## ArevaEPRDCPEm Resource

Attached is a DRAFT response for Question 07.01-35 of RAI No. 505 (FSAR Ch. 7) provided in the attached file in advance of the May 30, 2012 final date.

All indicated changes are in response to RAI 505, 07.01-35

Figure 7.3-56—SBVSE Battery Room Heater Control

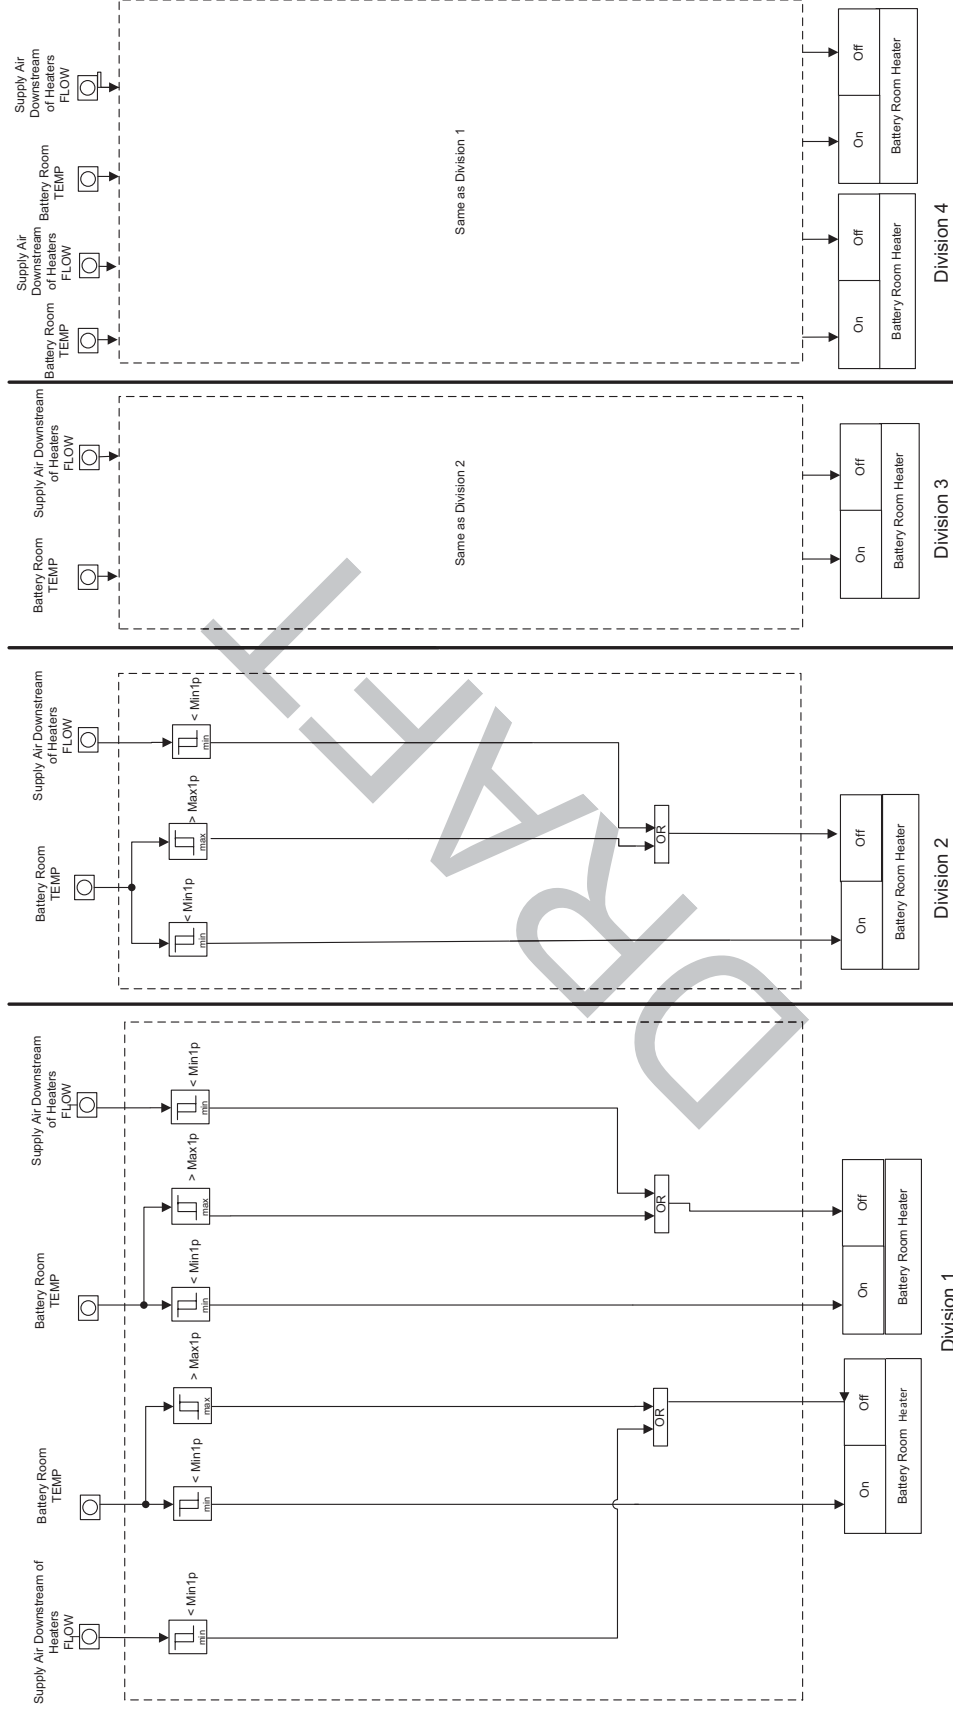
All indicated changes are in response to RAI 505, 07.01-35

Figure 7.3-57—SBVSE Battery Room Supply Air Temperature Control

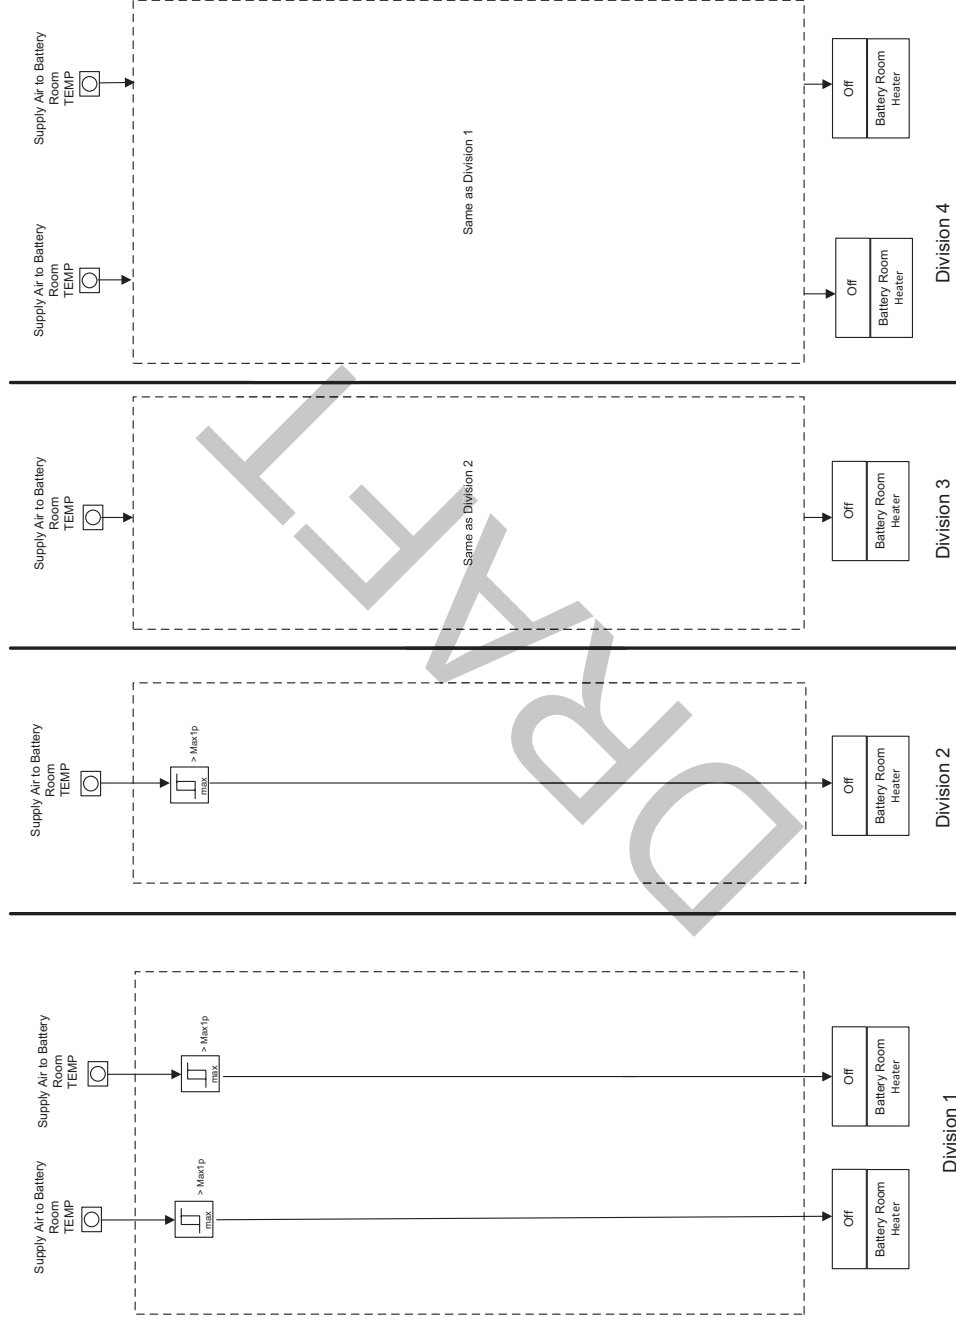
All indicated changes are in response to RAI 505, 07.01-35

Figure 7.3-58—SBVSE EFWS Pump Room Heat Removal

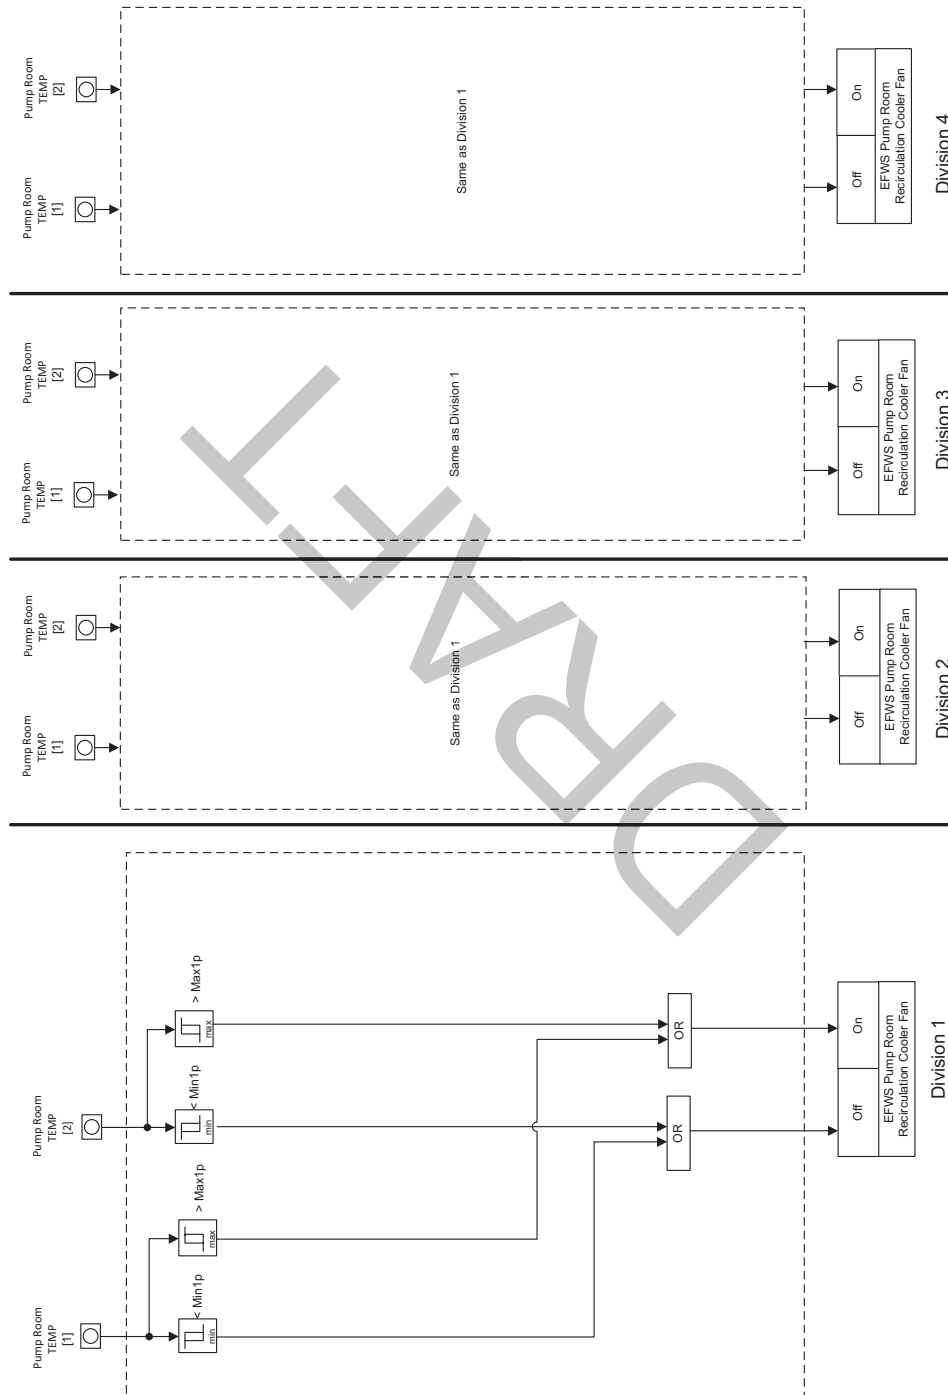
All indicated changes are in response to RAI 505, 07.01-35

Figure 7.3-59—SBVSE CCWS Pump Room Heat Removal

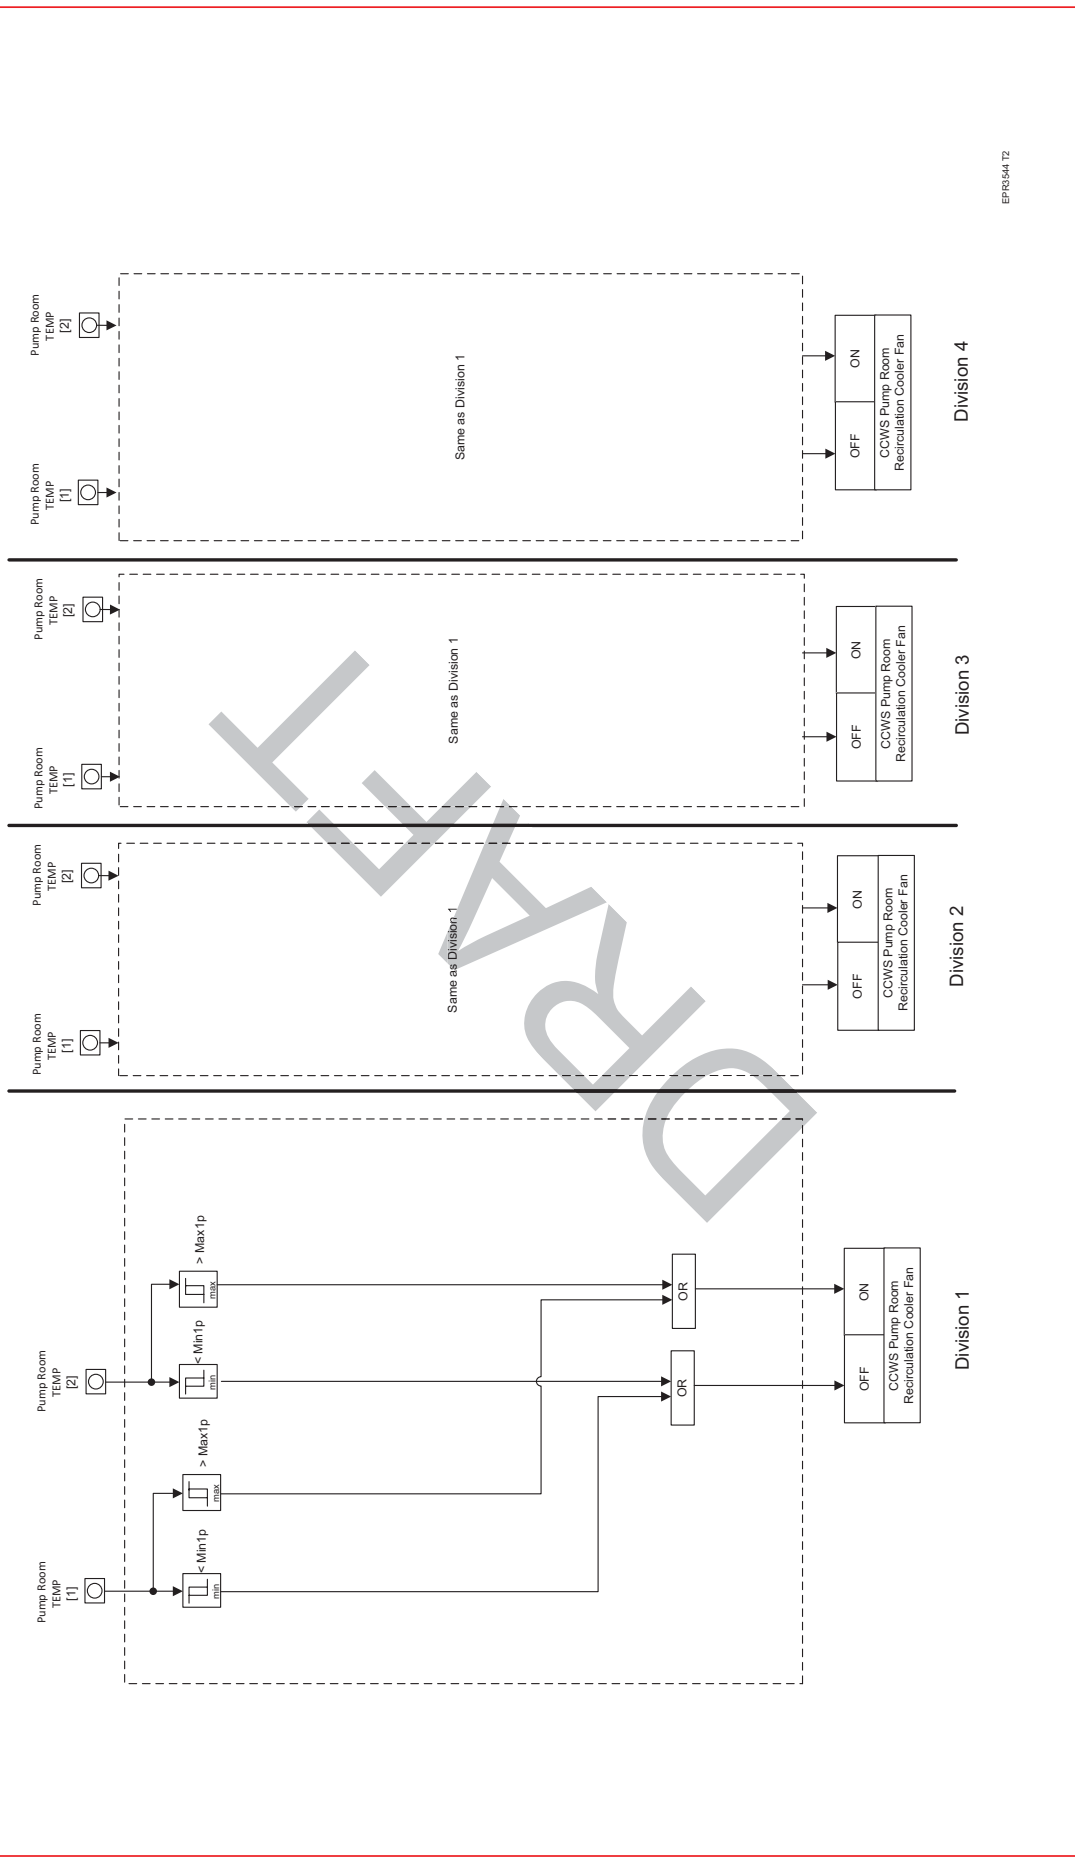
Electrical Division of Safeguard Building Ventilation System (SBVSE)	<del>Component Cooling</del> <del>Water System</del> CCWS Pump Rooms Heat Removal (Figure 7.3-59)	<u>This function is described in Sections 7.3.1.4.6 and 9.4.6. The SBVSE has a safety-related function to ventilate and maintain acceptable ambient temperature in the Safeguard Building areas and rooms ventilated by the system (GDC-4, GDC-17). The Component Cooling Water System Rooms Heat Removal function supports this system safety function by removing heat from the applicable rooms and maintaining room temperature within a temperature band for safety-related equipment.</u>	NO	N/A	N/A	The I&G associated with the SBVSE is described in Section 9.4.6.

All indicated changes are in response to RAI 505, 07.01-35

Figure 7.3-60—SIS / RHRS Automatic RHRS Flow Rate Control

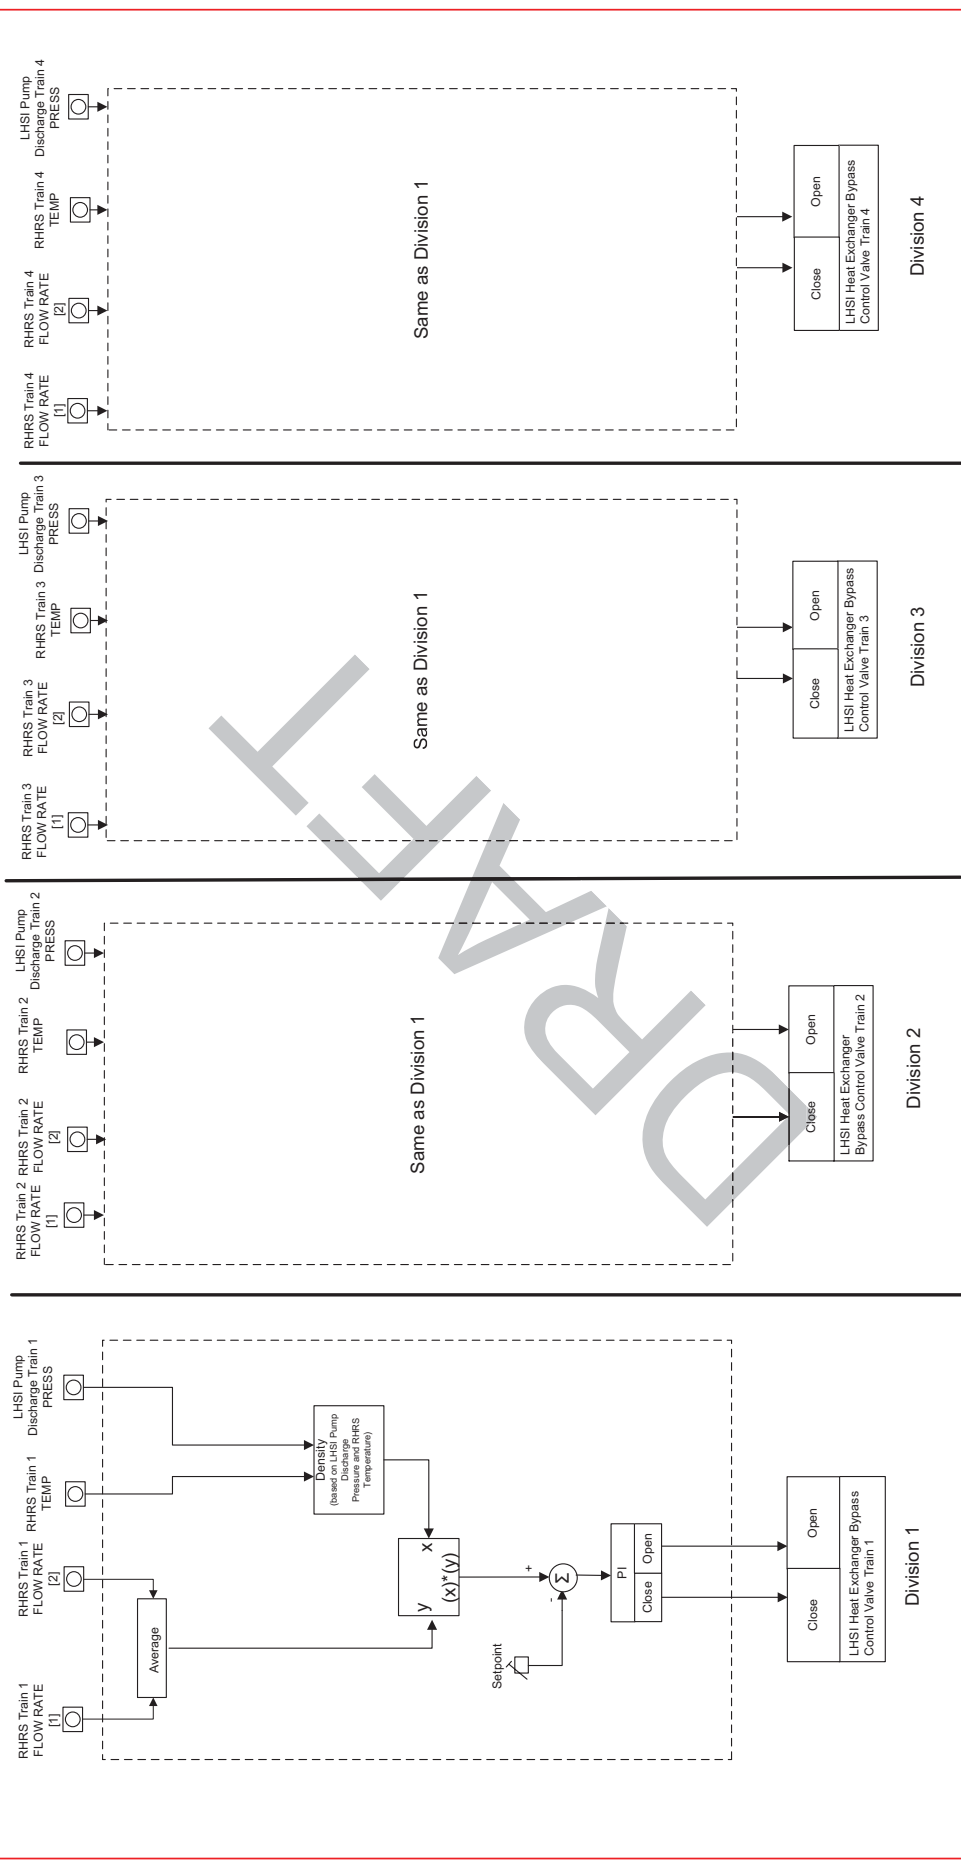
All indicated changes are in response to RAI 505, 07.01-35

Figure 7.3-62—Isolation of FBYS on Containment Isolation

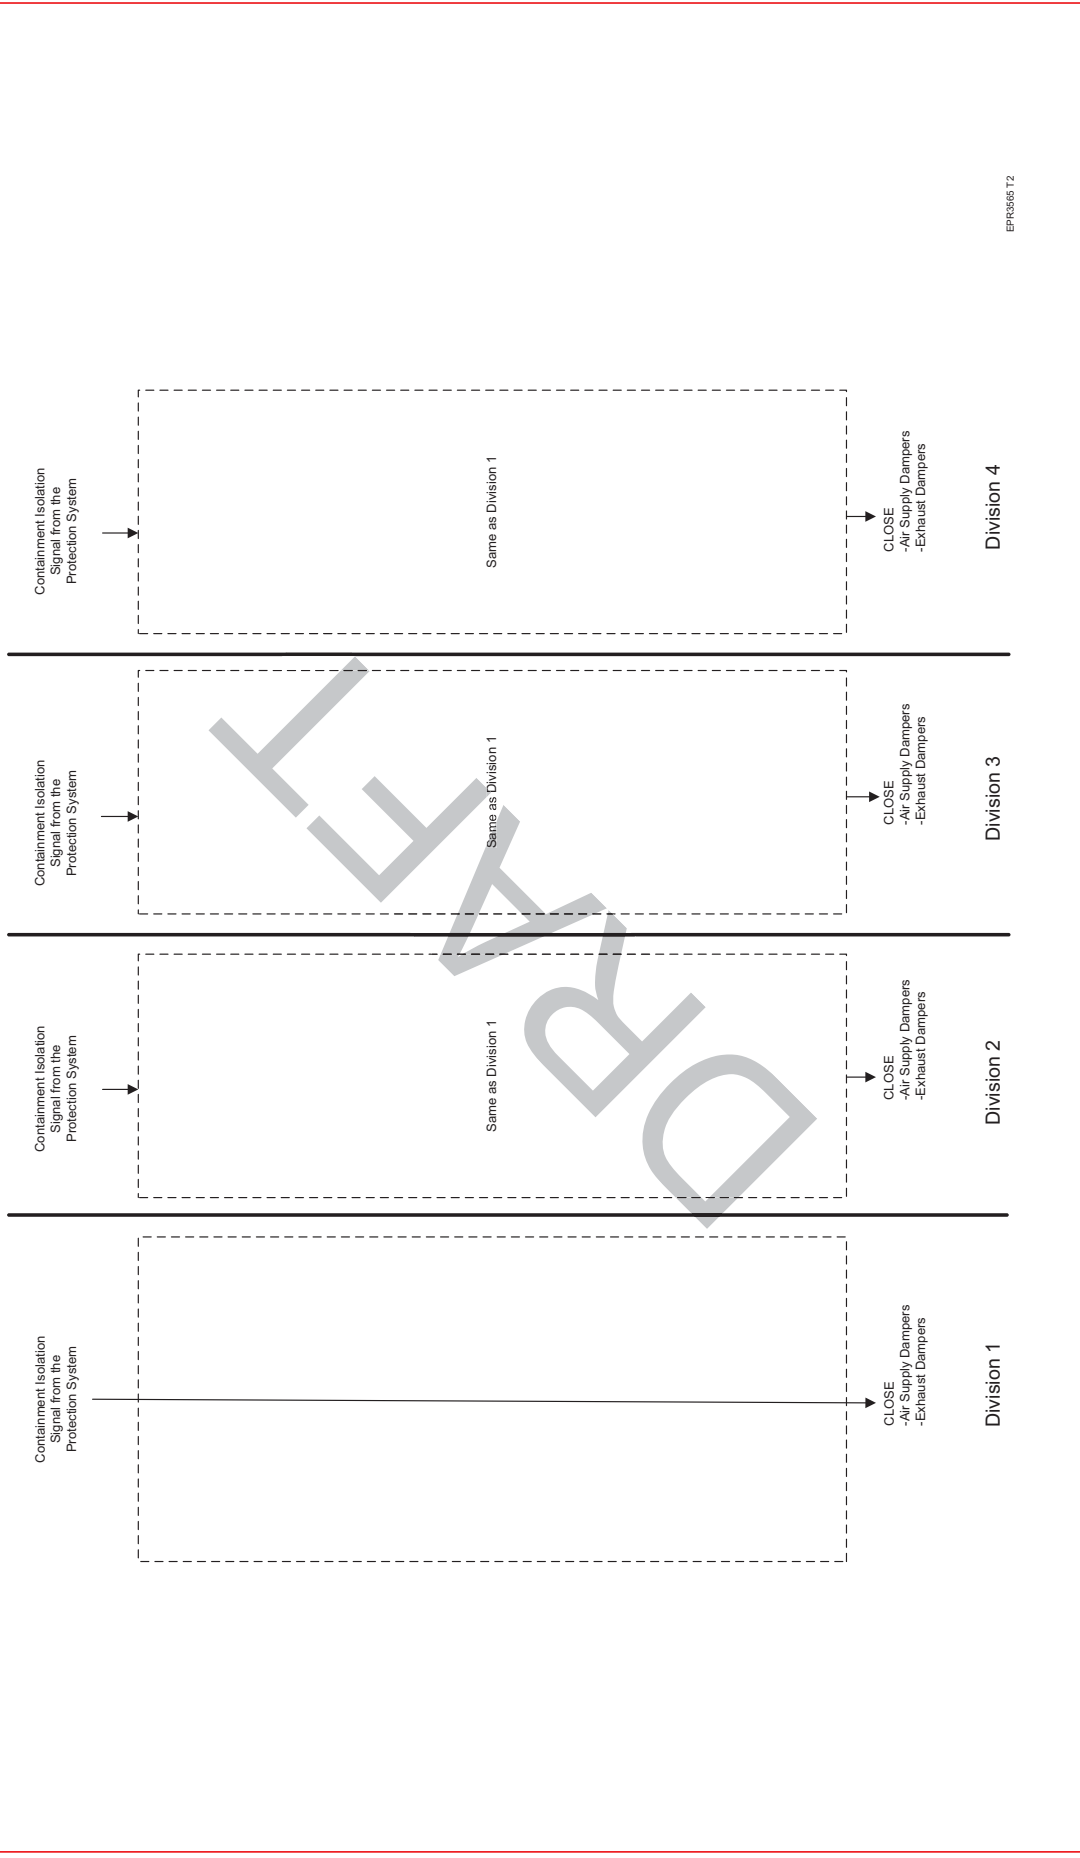
All indicated changes are in response to RAI 505, 07.01-35
